AINLEY GROUP FILE No. 21006-2

The chmielarchitects is proceeding with a Zoning By-Law Amendment and Site Plan Control for a proposed 9-storey building located at 797 Richmond Road in Ottawa, Ontario. The subject site is located at 797 Richmond Road approximately 540m east of Woodroffe Avenue, 80m west of the intersection of Cleary Avenue and Richmond Road

**Re: Site Plan Control and Zoning By-law Amendment Applications
797 Richmond Road – Second Submission**

1 SITE PLAN - GROUND FLOOR
 SP-002 SCALE 1:100

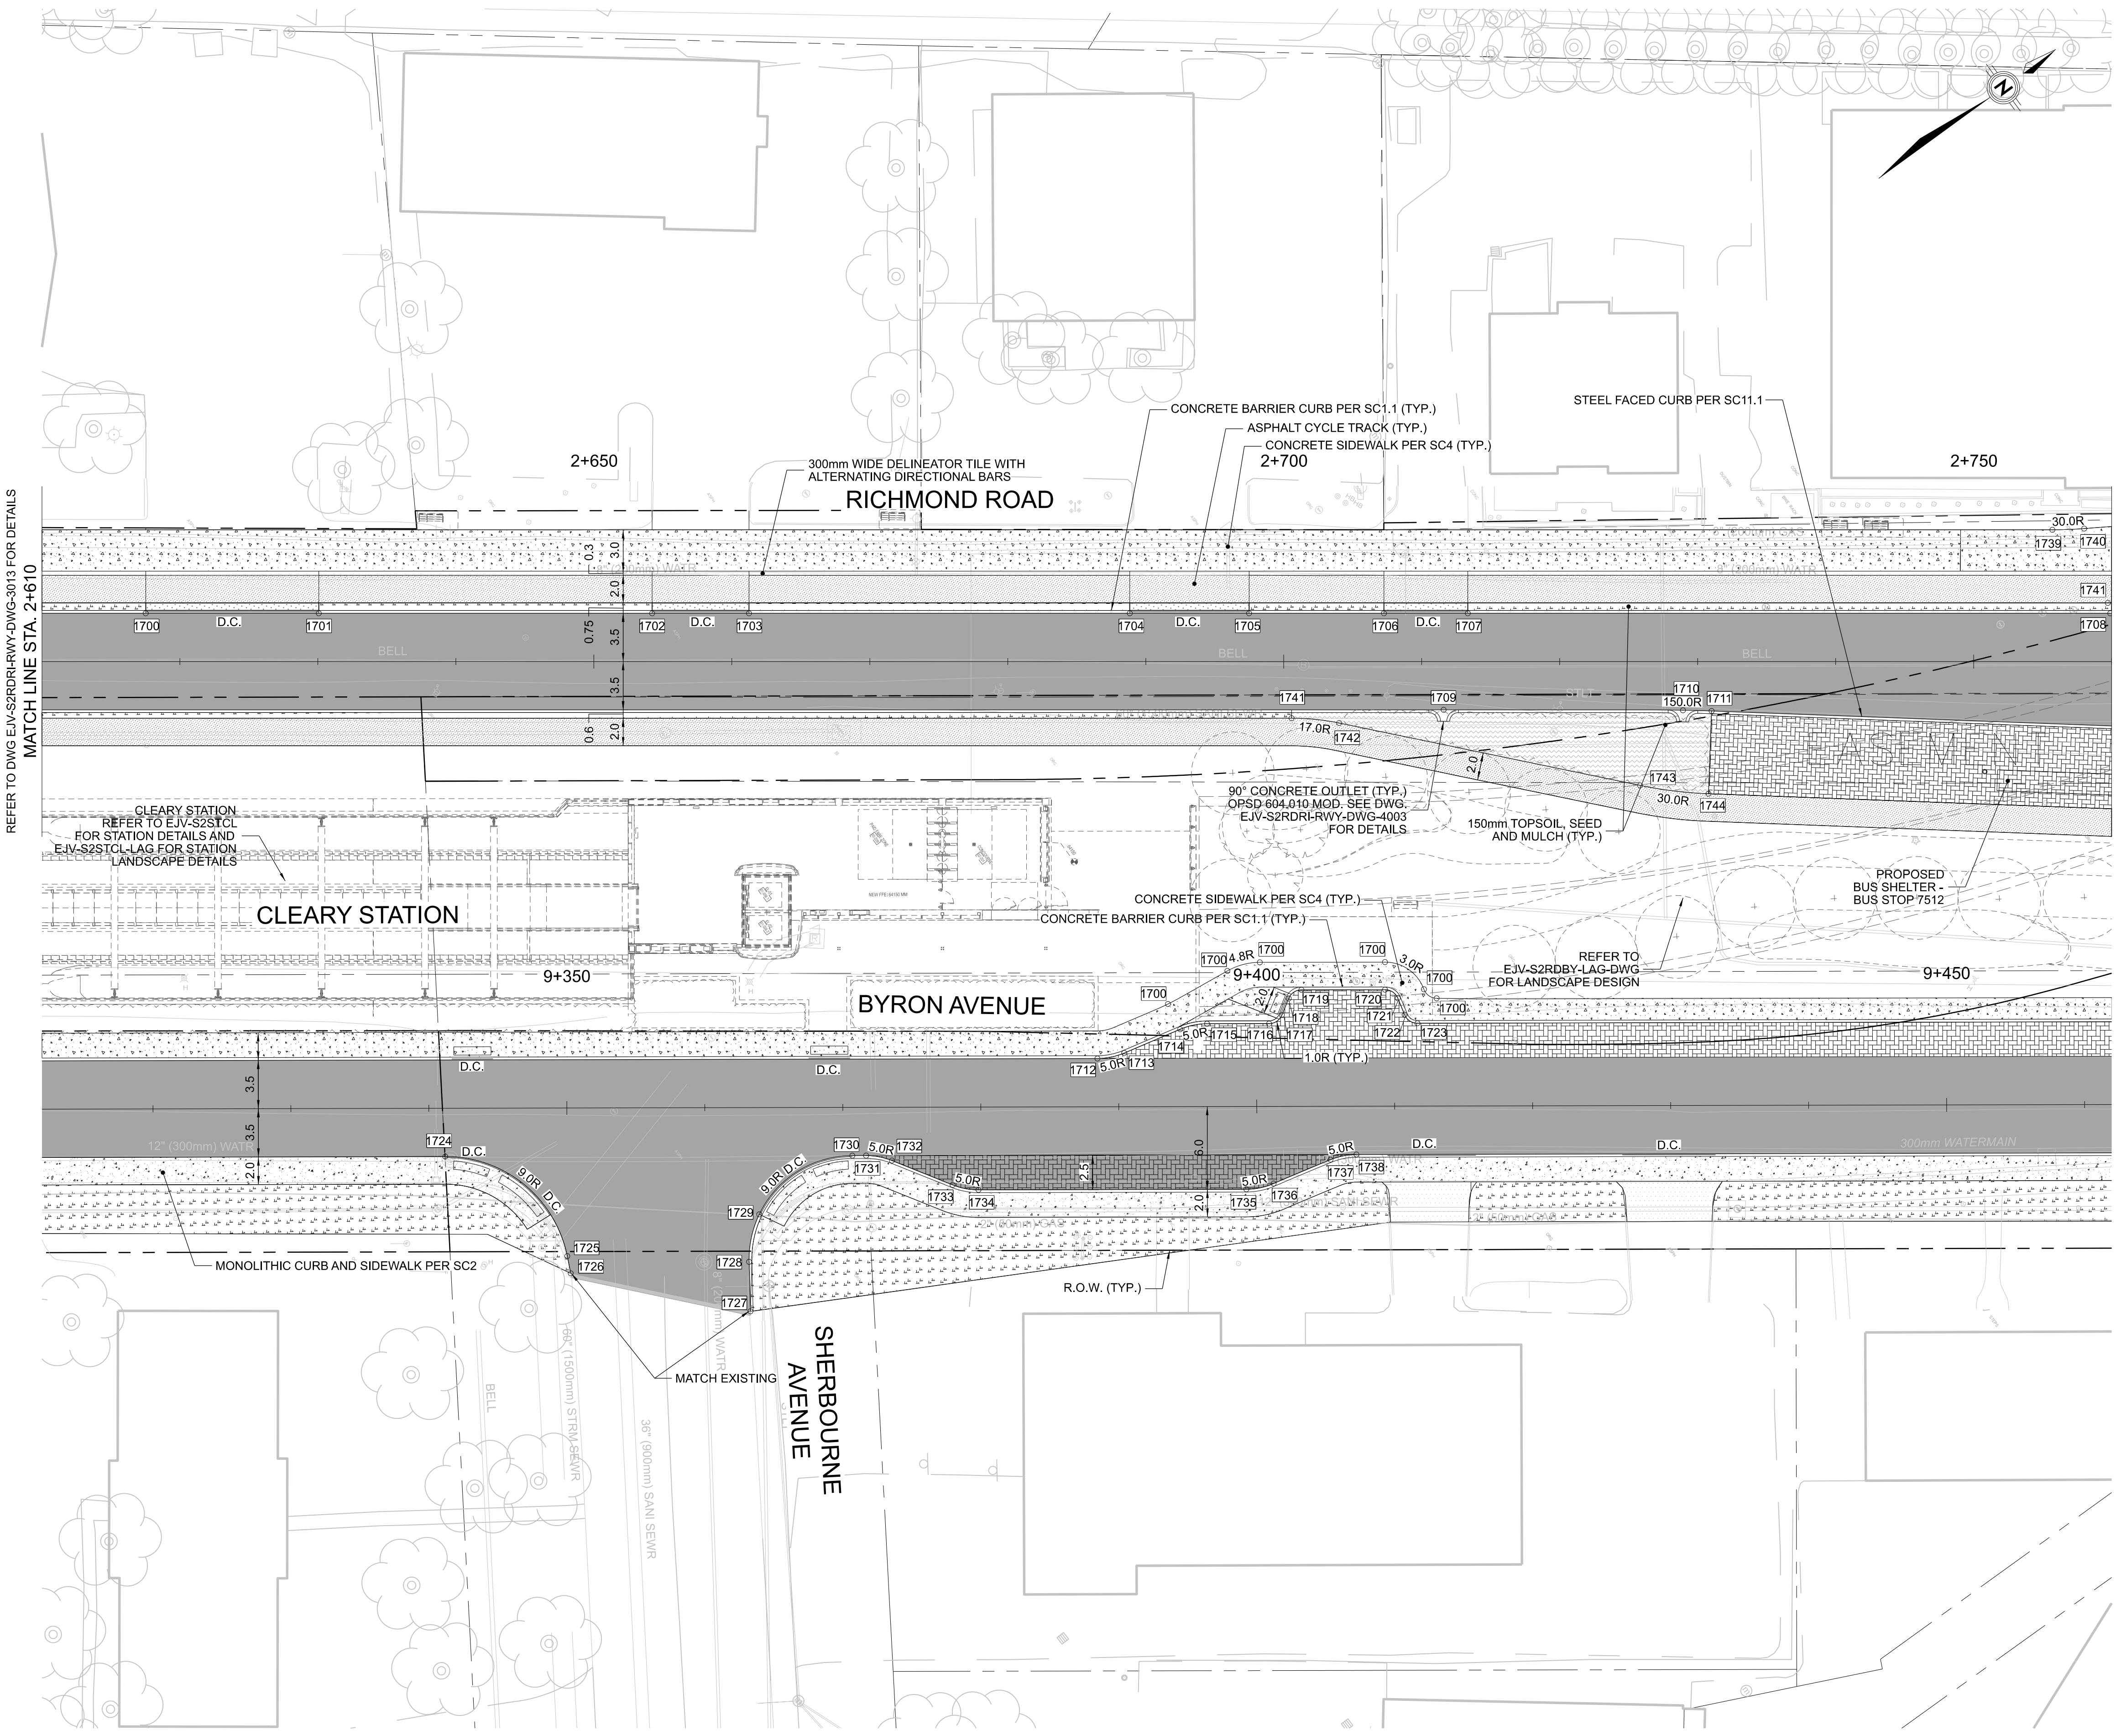
- 28.** The site access appears to be almost directly abutting the adjacent property line. This does not conform to Section 25.1.p of the PABL.
- 29.** Illustrate the proposed reconstruction of Richmond Road on the site plan drawings. Indicate where the proposed 3m sidewalk and 2m cycle track (part of the Richmond Road design) will be in relation to the property line.
- 30.** The proposed site layby is not accepted for various reasons:

- 31.** Figure 4 shows a 19% underground parking ramp slope. Slopes exceeding 15% can be a psychological barrier to some drivers. When the underground parking ramp's slope exceeds 8%, a vertical-curve transition or a transition slope of half the ramp should be implemented. In addition, when the slope is exceeding 6%, a subsurface melting device should be used.

- 32.** Cyclists will be very challenged to use the underground parking ramp. Review and provide a more comfortable option for cyclists to access bike storage. Also consider providing a more sheltered and secure exterior bike storage especially the spaces behind the building.

47. My only concern with this site plan is at the exit of the garbage room there is a parking spot that should not be there unless barriers are installed and a walking of 2.2 m is given to bring the bins out.
